BALTIMORE COUNTY PUBLIC SCHOOLS

ADDENDUM NUMBER 2

BID NAME: NEW SCHOOL CONSTRUCTION LANSDOWNE ELEMENTARY SCHOOL
DEMOLITION OF LANSDOWNE ELEMENTARY SCHOOL

BID NUMBER: **MBU-516-17**

ADD. NO. 2
SK-A-2.10

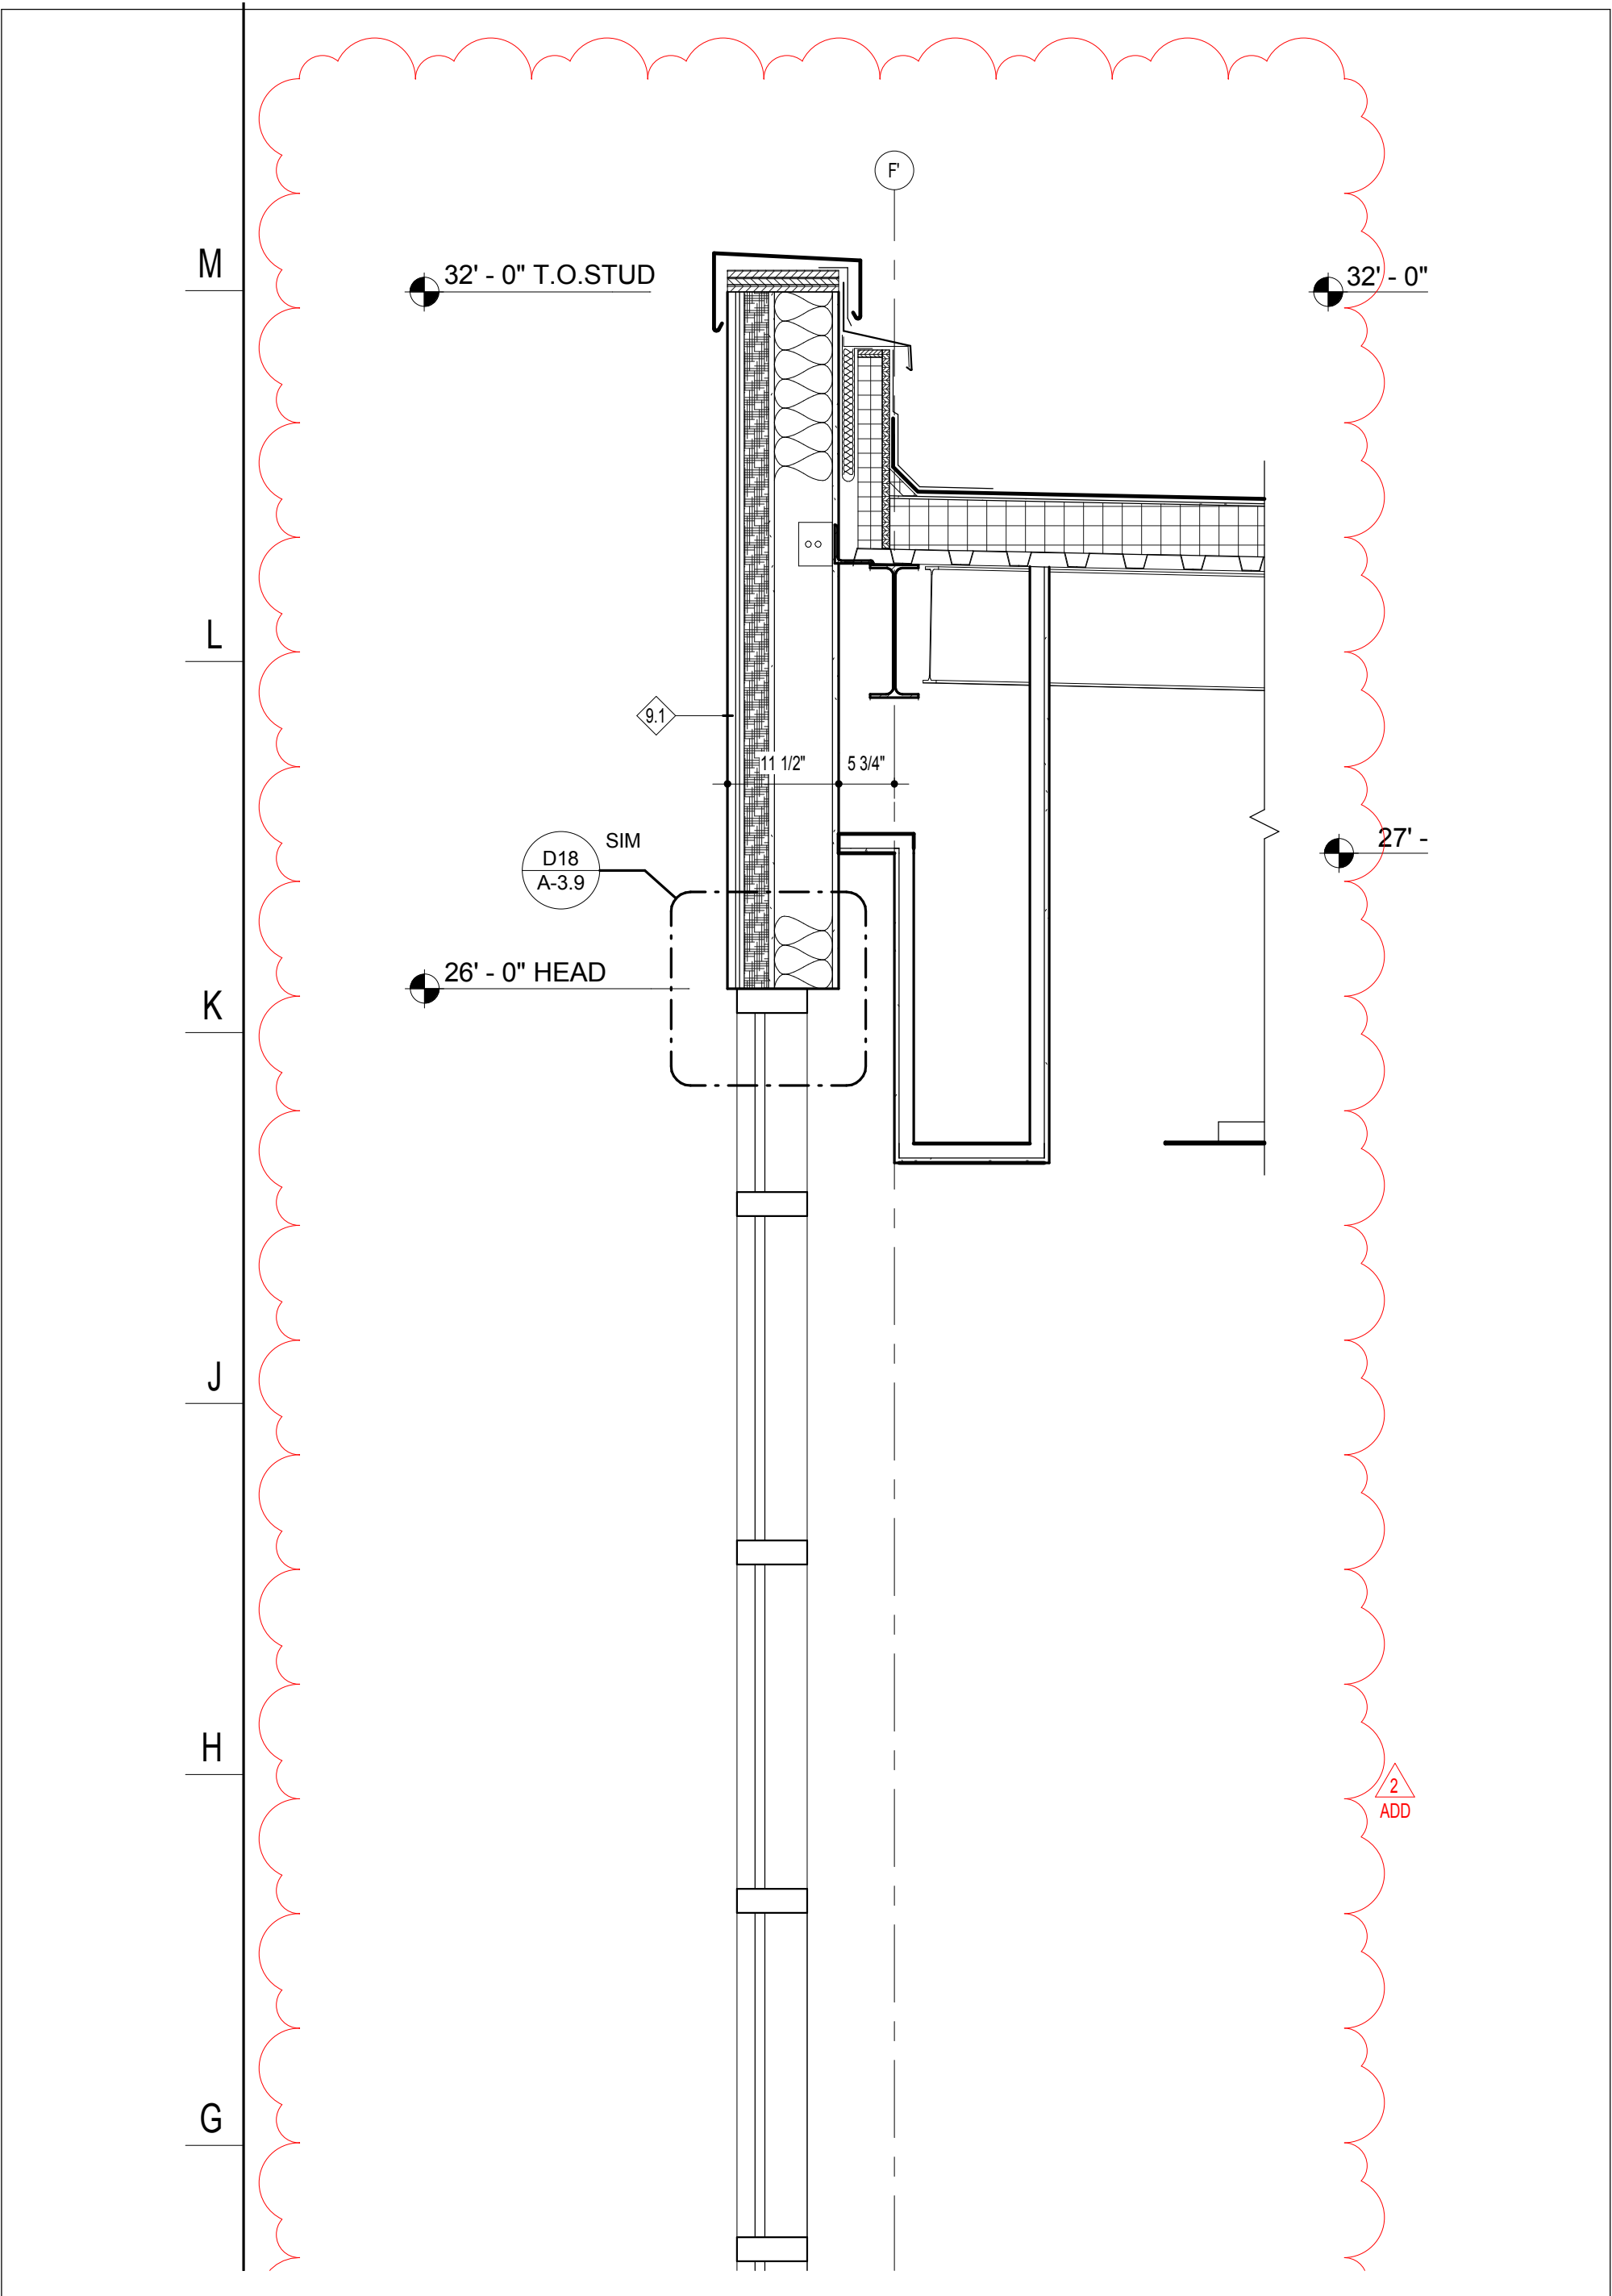
REVISE Tile wall finish and base for rooms B117 and C137 to "PT."
- 4.5. SHEET A-3.2, DOOR SCHEDULE**
REVISE HM frame type for doors E008, E011, E012, E013 to 42.
REVISE HM frame type for doors A106 and A123 to 22.
ADD "Note 25 Provide integrated metal door assembly." To Notes for remarks column.
ADD Note 25 to notes for remarks column at doors C10, C12, C20 and C22.
REVISE All exterior storefront doors to door type FG2.
- 4.6. SHEET A-3.6, FRAME ELEVATIONS – INTERIOR**
ADD Dimensions to frame 20 per attached sketch SK-A-2.9.
- 4.7. SHEET A-3.7, FRAME ELEVATIONS – INTERIOR**
ADD HM frame designation 42 to undesignated frame to the right of HM frame 41.
- 4.8. SHEET A-4.3, WALL SECTIONS**
ADD Batt insulation to fill stud cavity at exterior wall types 2.1, 7.1, 7.2, and 9.1.
- 4.9. SHEET A-4.5, WALL SECTIONS**
ADD Wall section A18/A-4.5 per attached sketches SK-A-2.10 and SK-A-2.11.

ADD. NO. 2
SK-A-2.12

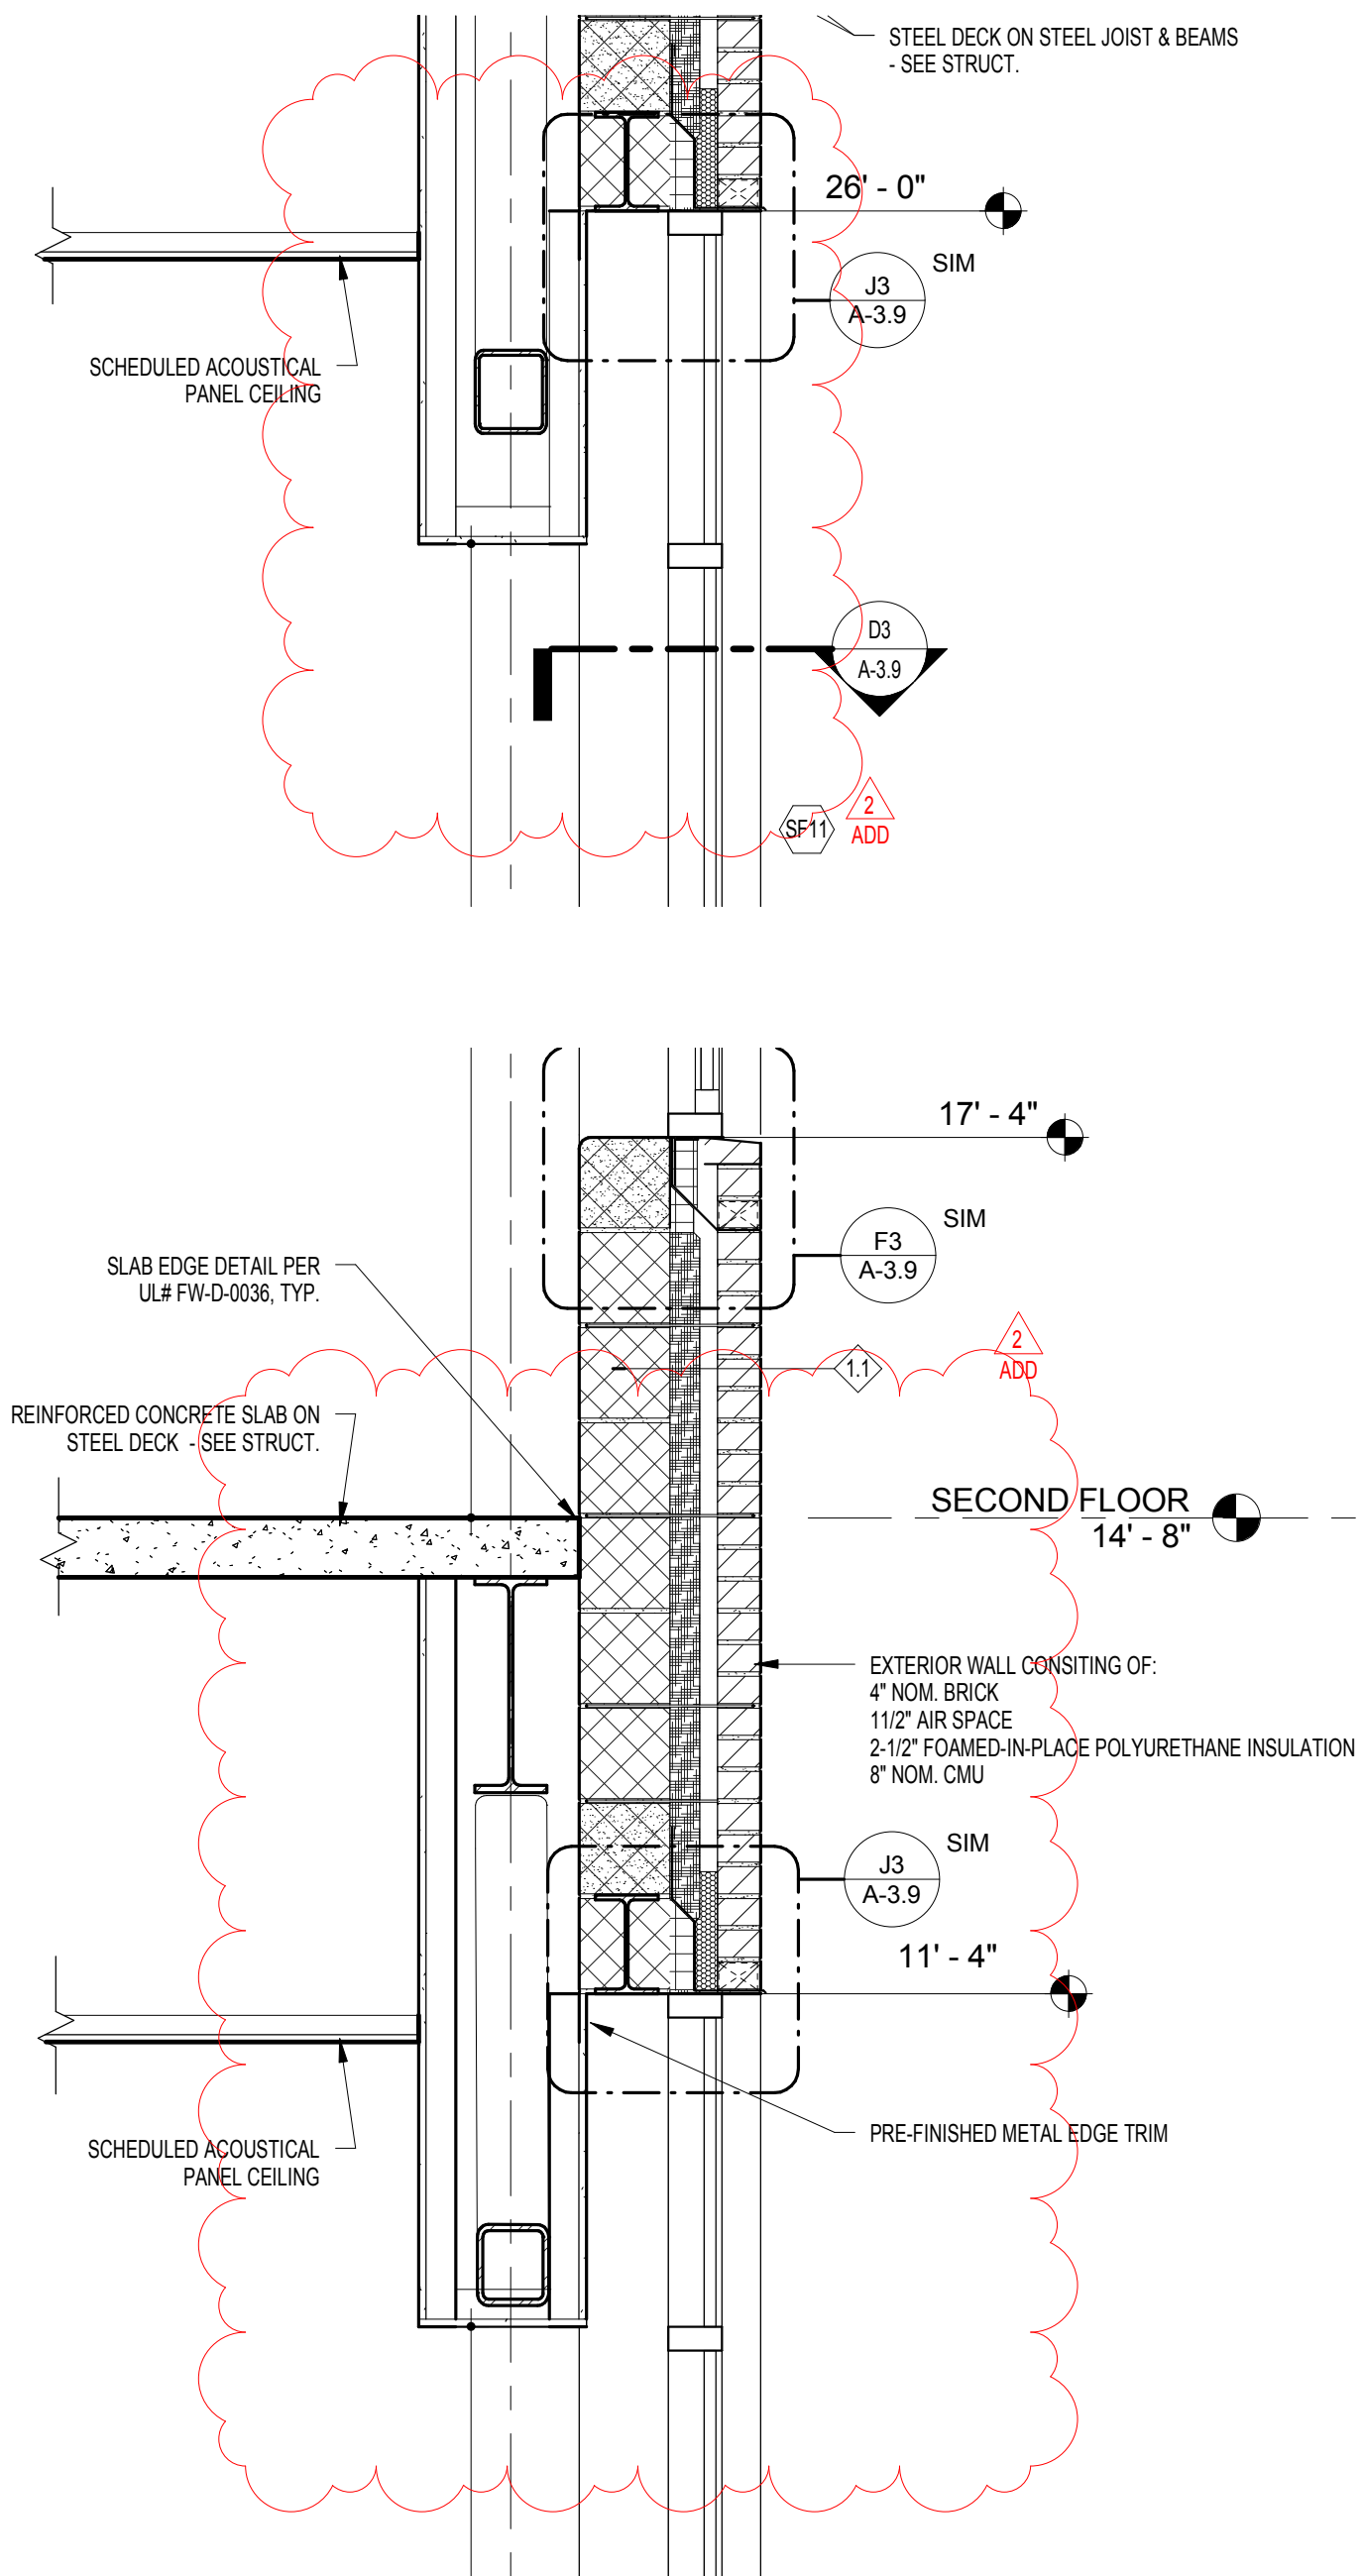
- 4.10. SHEET A-4.6, WALL SECTIONS**
ADD Reference F5/A-1.4 to sill of door to green roof wall section in A14/A-4.6.
ADD Wall section J11/A-4.6 per attached sketch SK-A-2.12.

ADD. NO. 2
SK-A-2.13

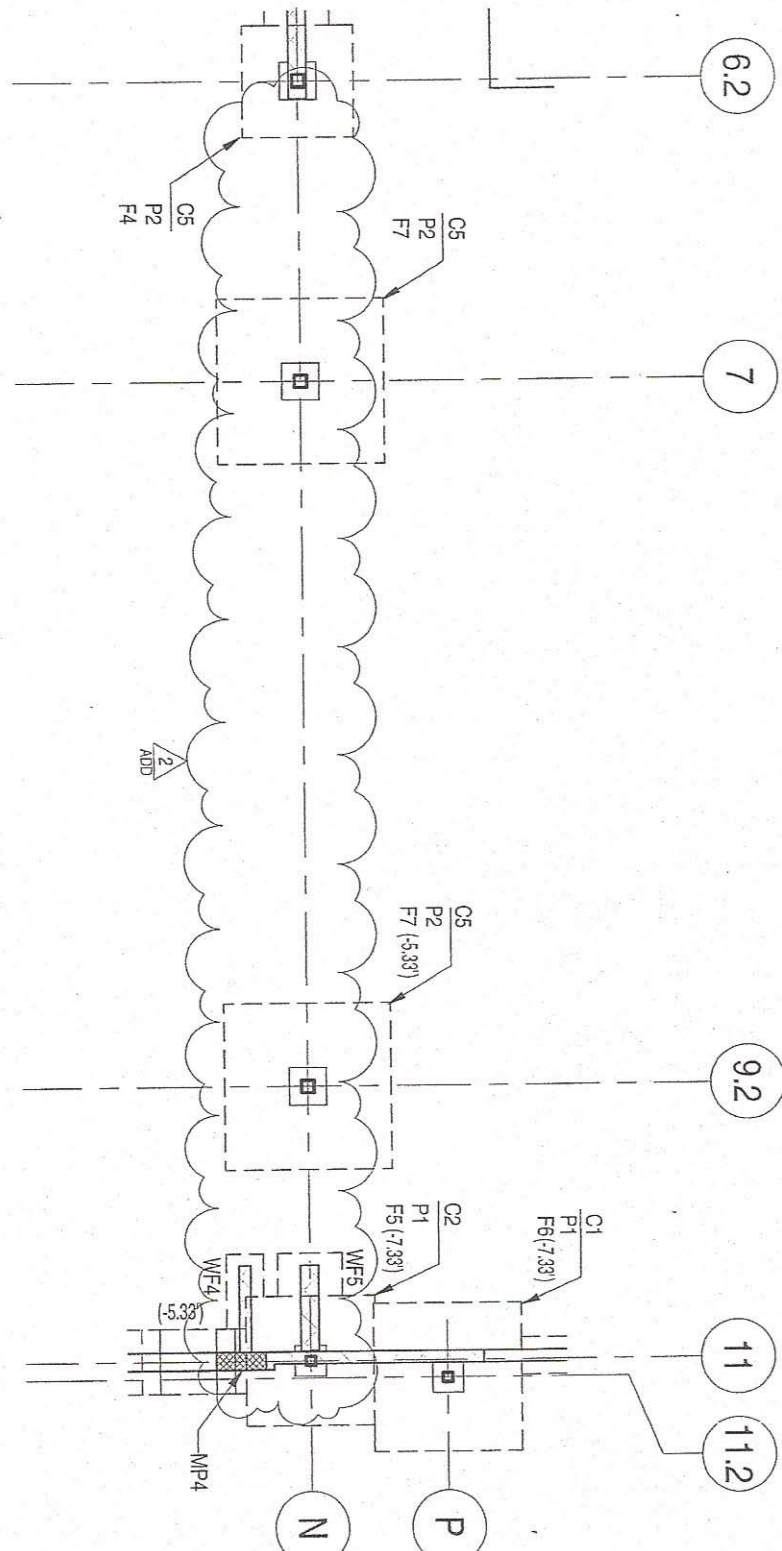
- 4.11. SHEET A-4.11, WALL SECTIONS**
REVISE Section A18/A-4.11, per attached sketch SK-A-2.13.
- 4.12. SHEET A-4.13 WALL SECTIONS**
ADD Reference F13/A-1.5 on high eave of clerestory that faces east.

ADD. NO.2
 SK-S-2

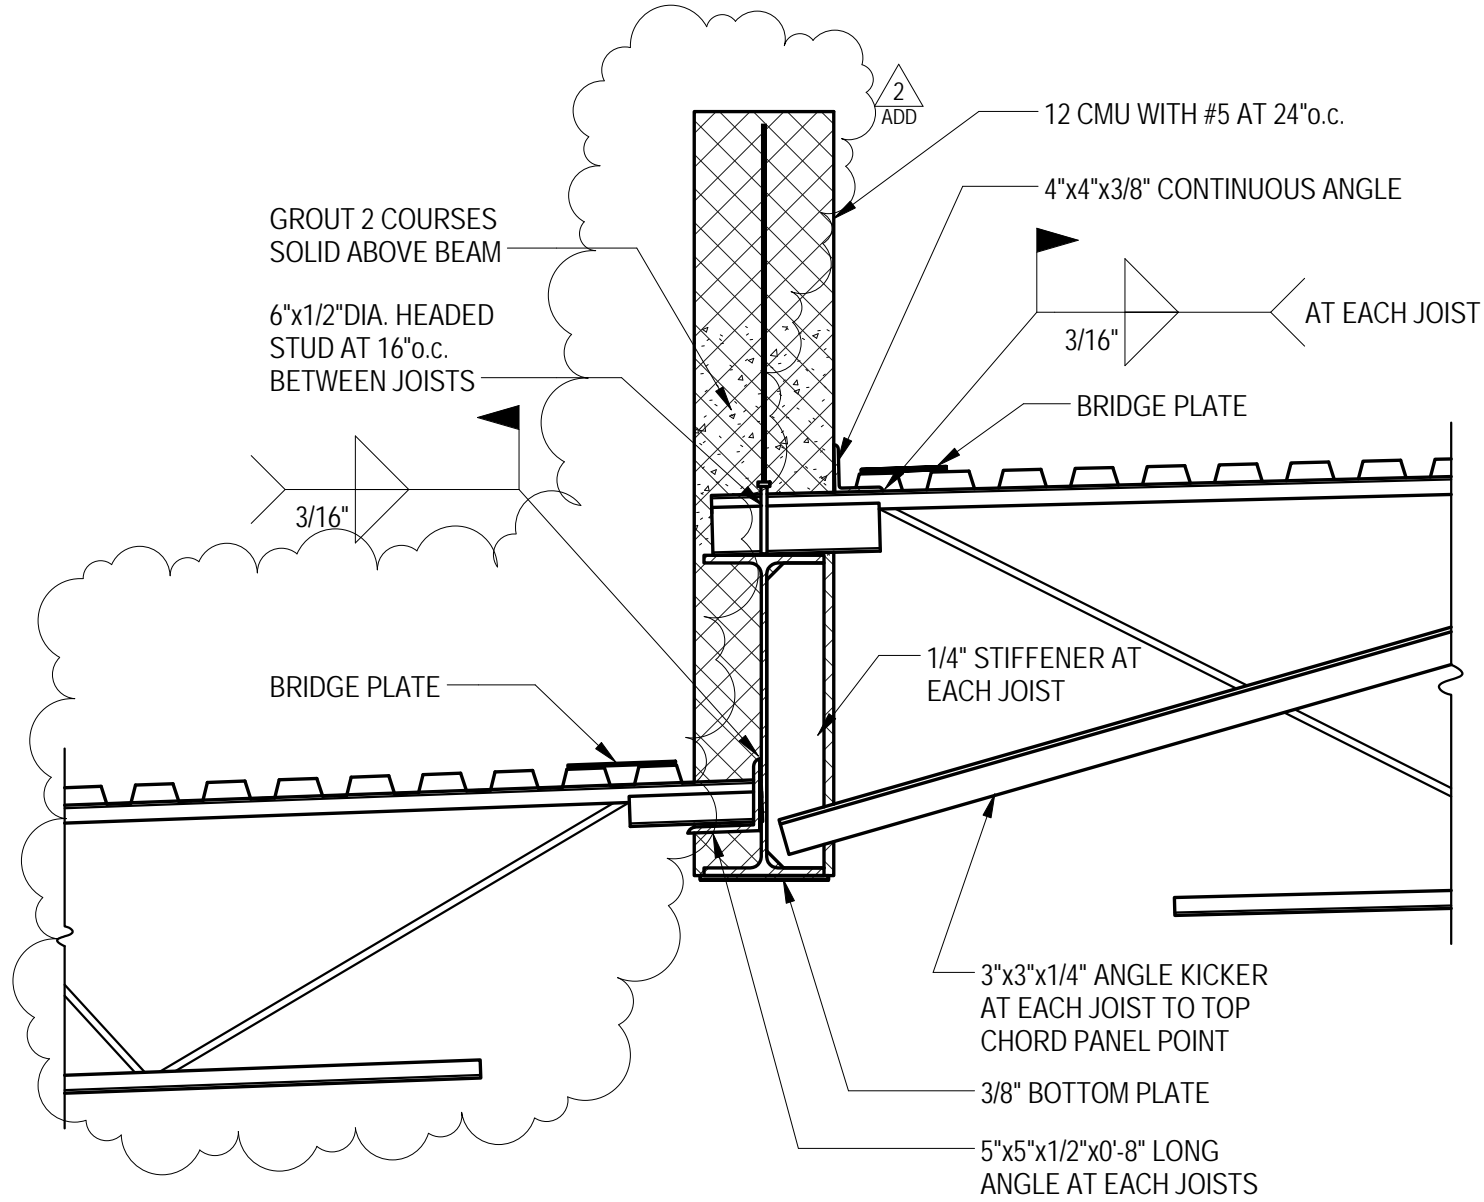
- 5.10. SHEET S-5.1, SECTIONS
REVISE Section G/S5.1 per attached sketch SK-S-2.
- 5.11. SHEET S-5.2, SECTIONS
REVISE Section A/S5.2 per attached sketch SK-S-3.
